2004.07.30 Hw
minor
mod

Re: Minor Modification for re-configuring piping
EPA I.D. No: NYD002014595
DEC Part 373/Air Permit No.3-3340-00027/4-0
Cohoes (C), Albany County

Re: Norlite Corporation
6 NYCRR Part 373 Permit No. 4-0103-16/16-0
6 NYCRR Part 373 Minor Permit Modification-reconfigure piping
for permitted hazardous waste tanks

The following modifications involve changes to the piping of the permitted hazardous waste storage tanks 335-300, 400, 500 & 600 (outside tanks). The revised drawings reflect the following changes:

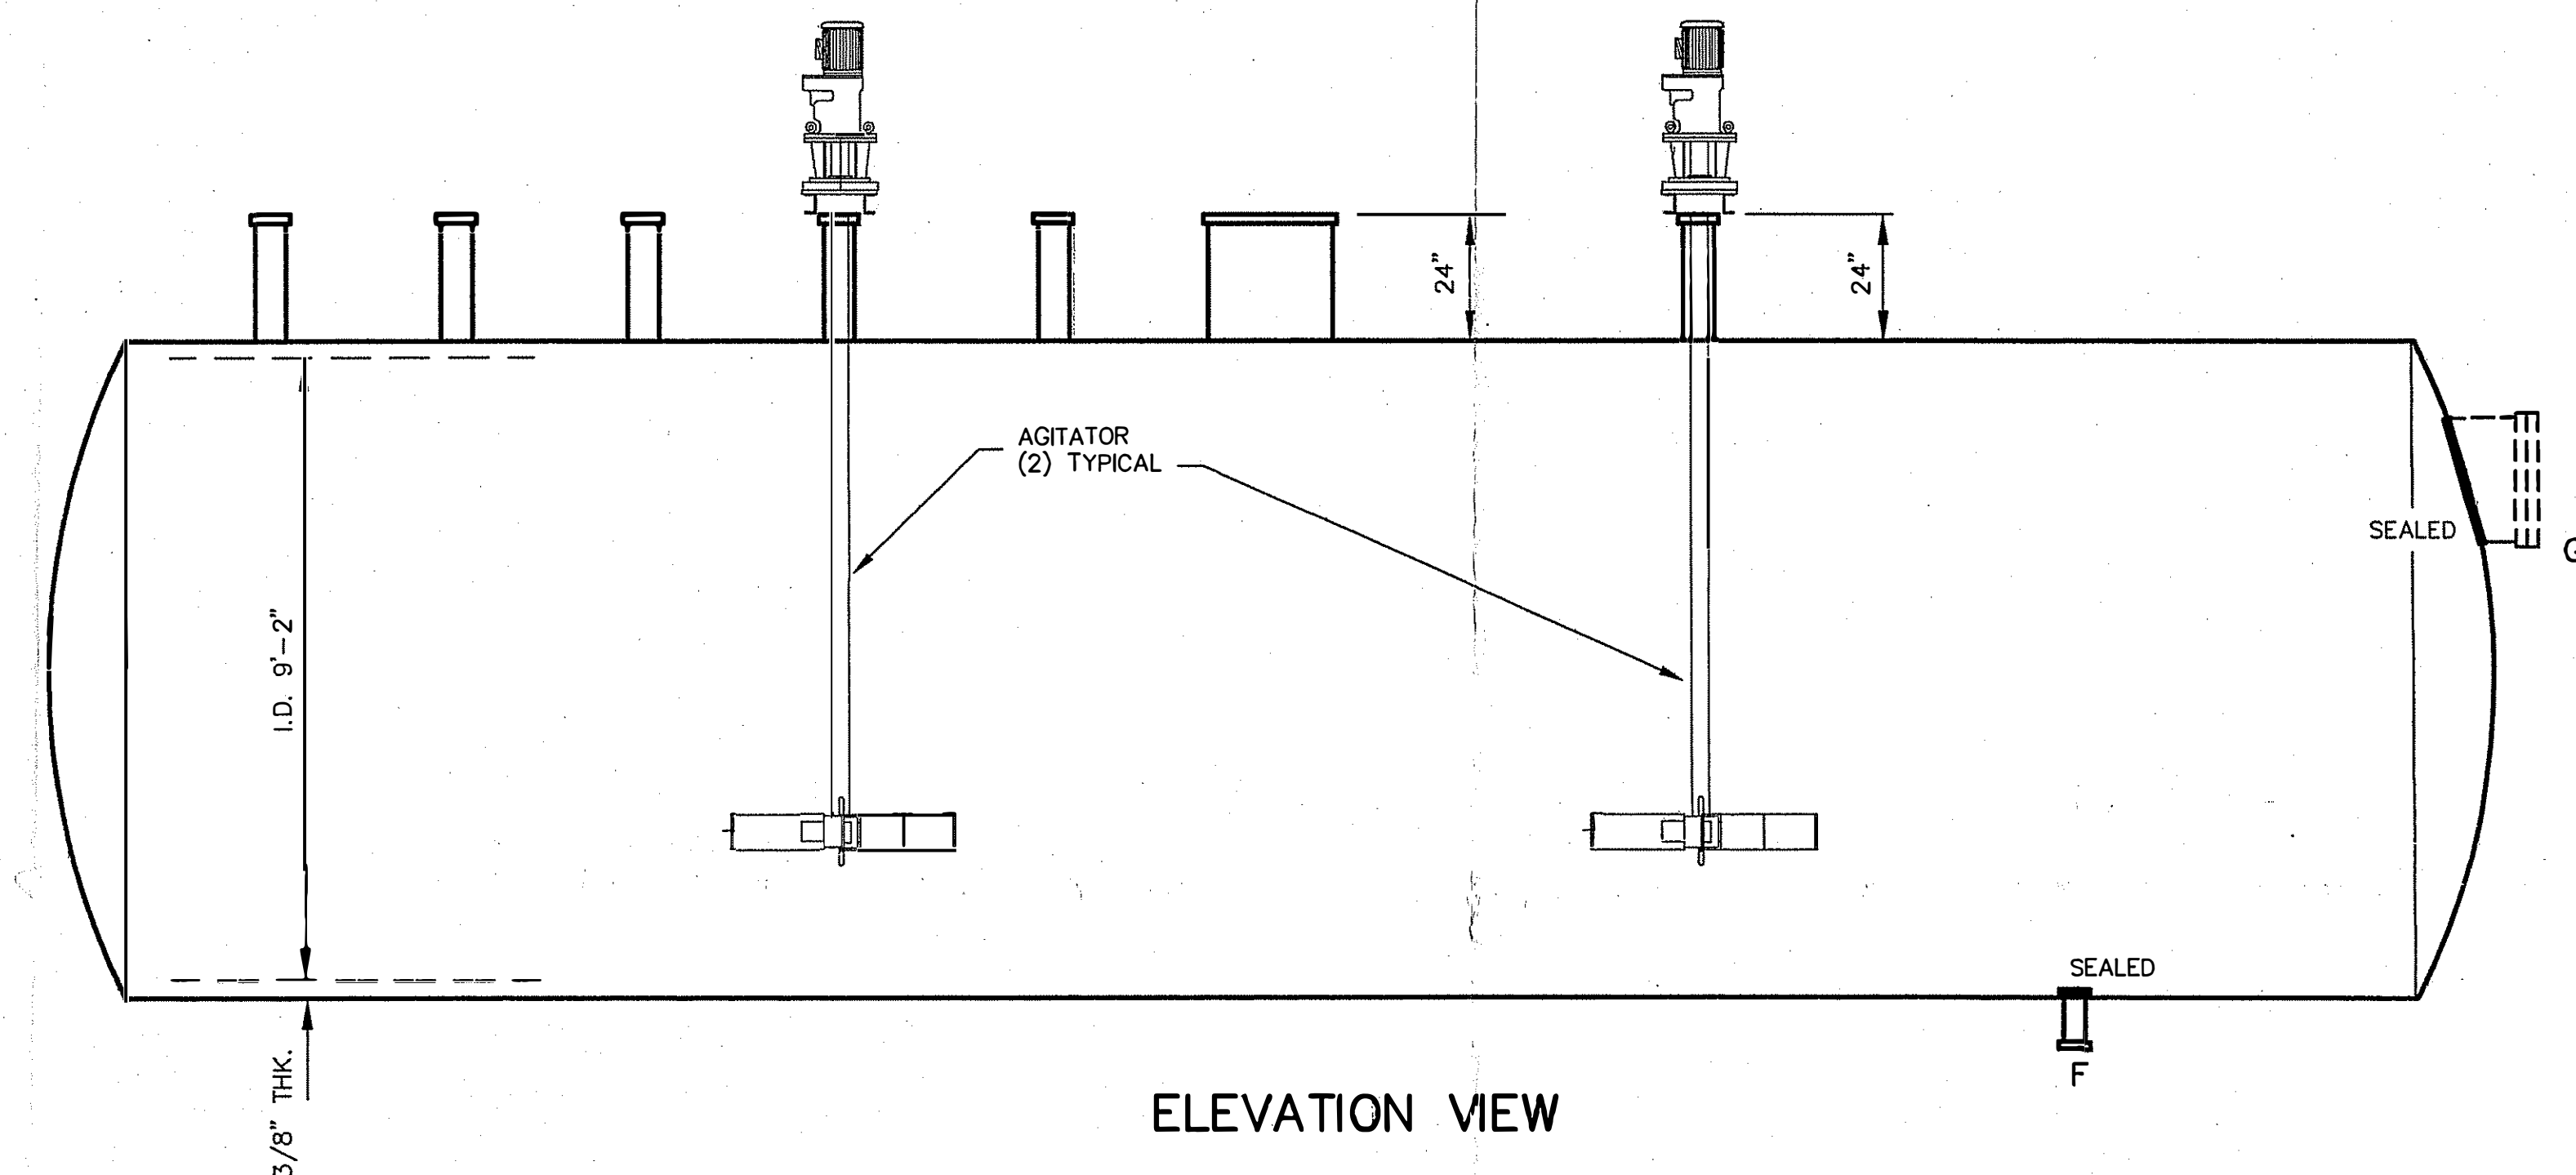
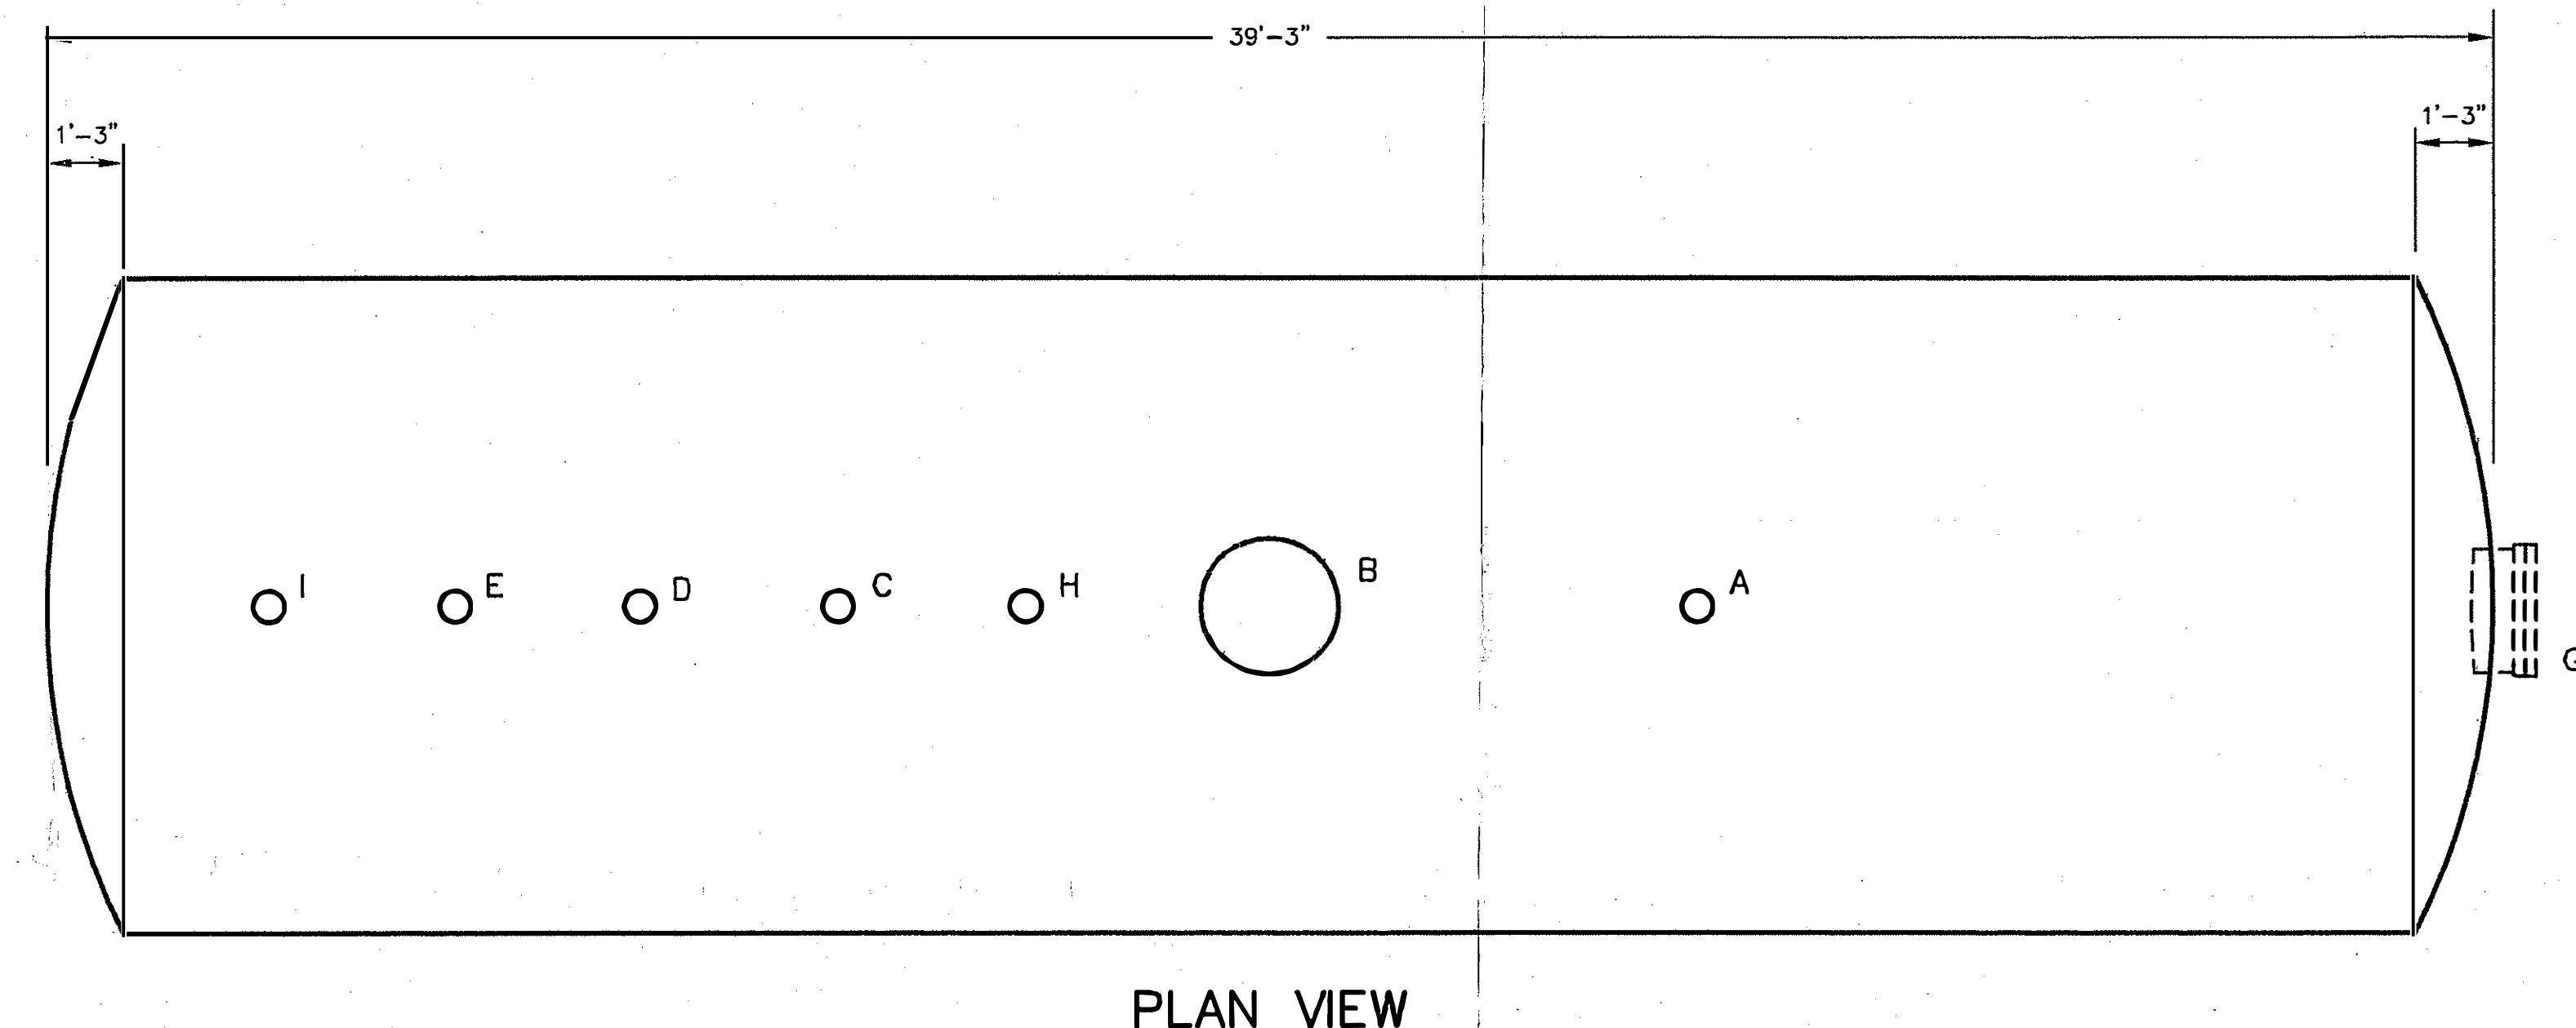
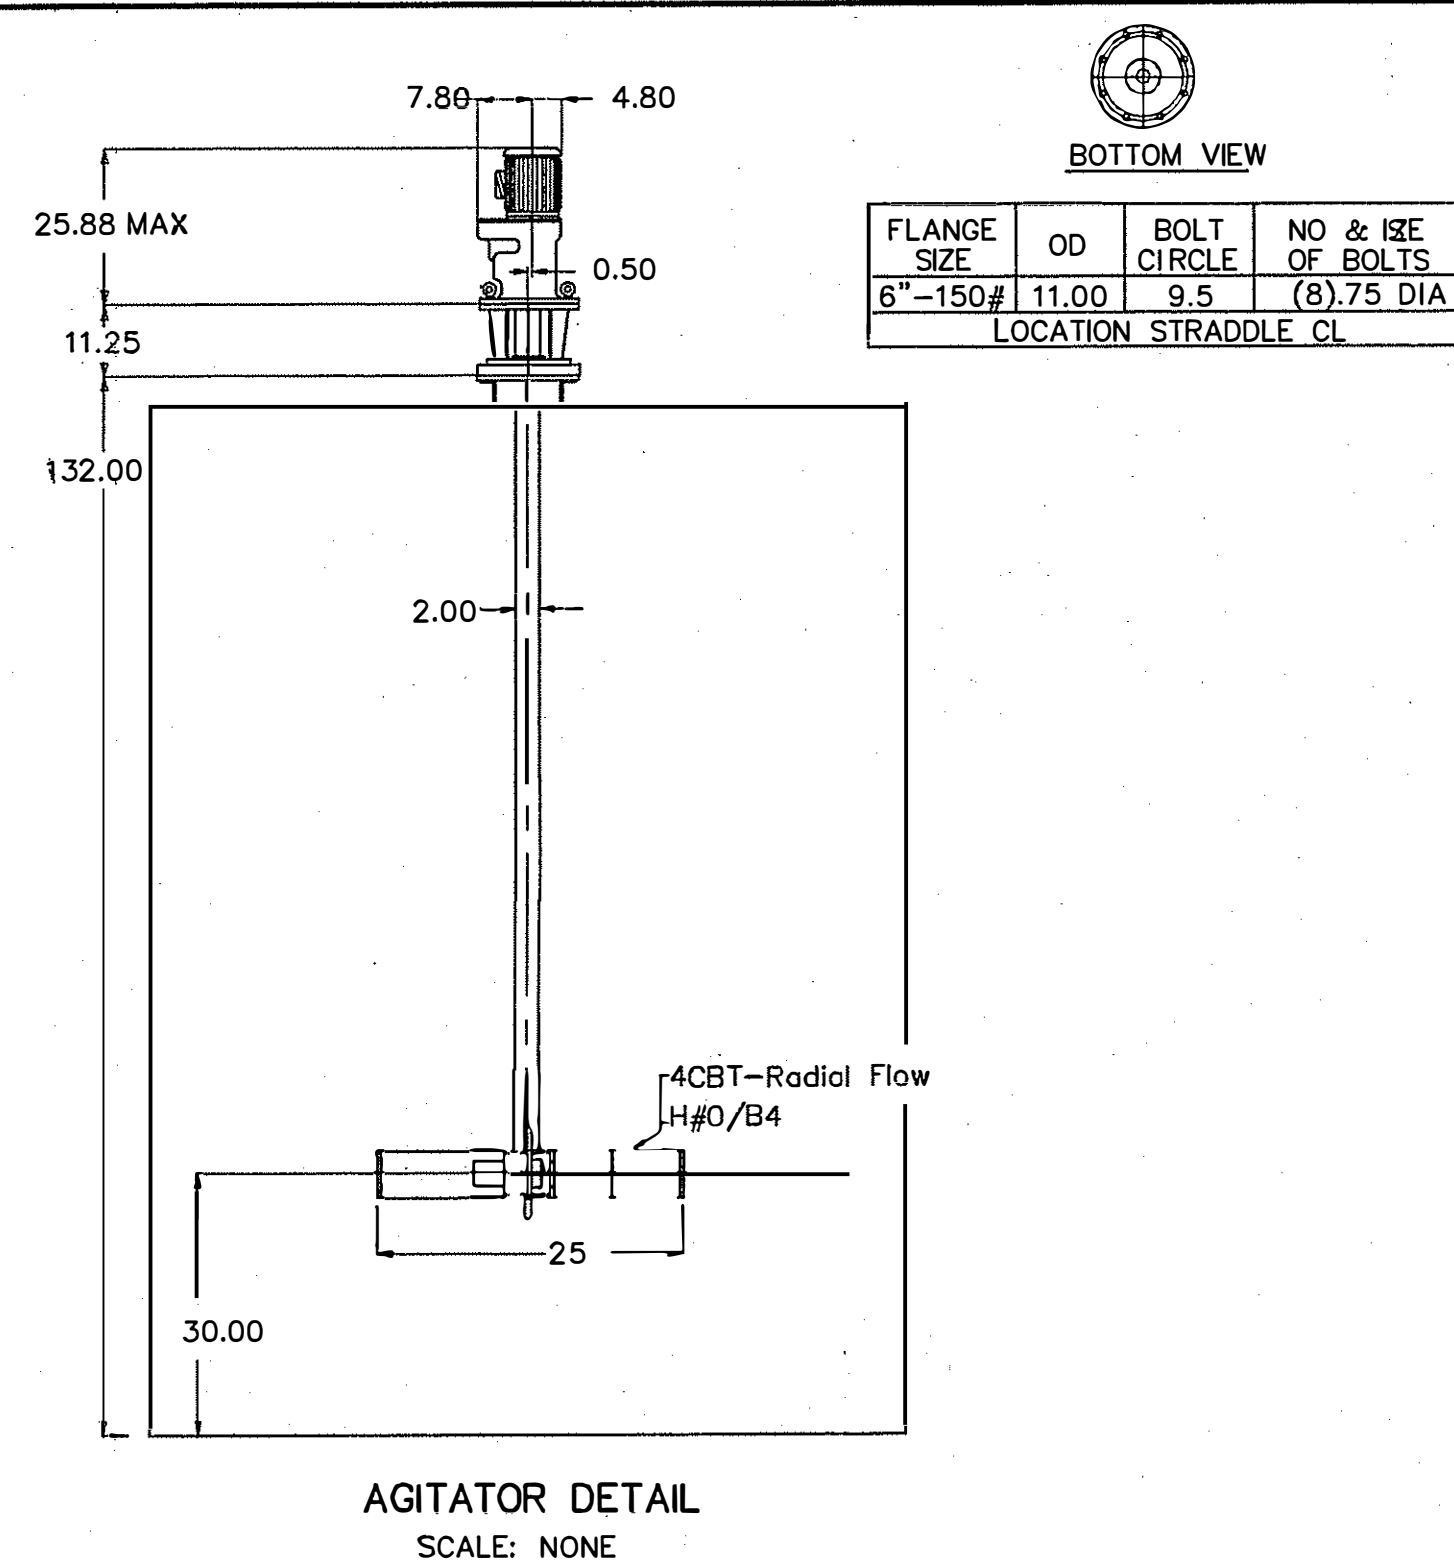
- The installation of new piping, valves and tank nozzles will allow Norlite to unload directly from Unloading Area #2 to the outside tanks. These modifications are shown on drawings: NY003-1317, NY003-5432, NY003-5433 and NY003-5434.
